TENDER
PUMPING STATION 17 UPGRADES

Project #2408-1498

ADDENDUM #1

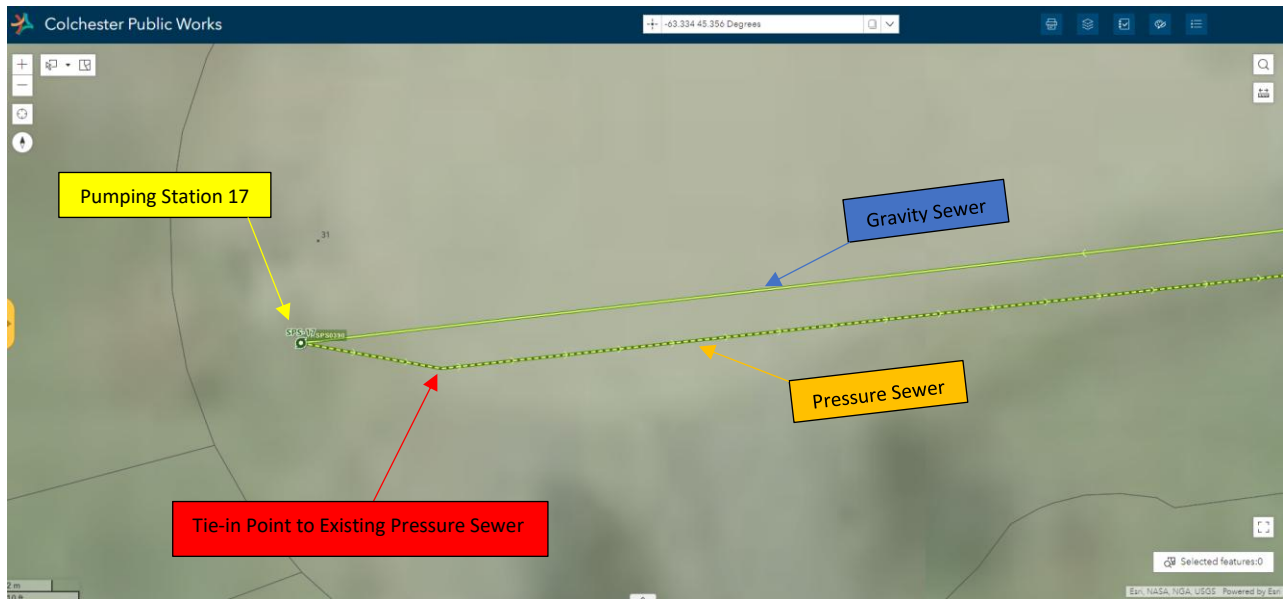
A. Question: What is the piping limit / tie-in point? We propose the first flanged joint inside the pump chamber.

B. Question: *Is the first flange inside the chamber in suitable condition to use as a tie-in point?*

Answer: After further investigation, it has been determined that the tie-in point for the pressure sewer is to be the angled connection point located approximately 5.75m outside of the wet well (see below screenshots from municipal asset viewer for more details). The gravity sewer tie-in will remain inside the wet well.

Answer: The condition of the flange inside the chamber has been determined to not be in acceptable condition for a connection. See above, the new tie-in point has been noted. Excavation and reinstatement of gravels and asphalt will be required.
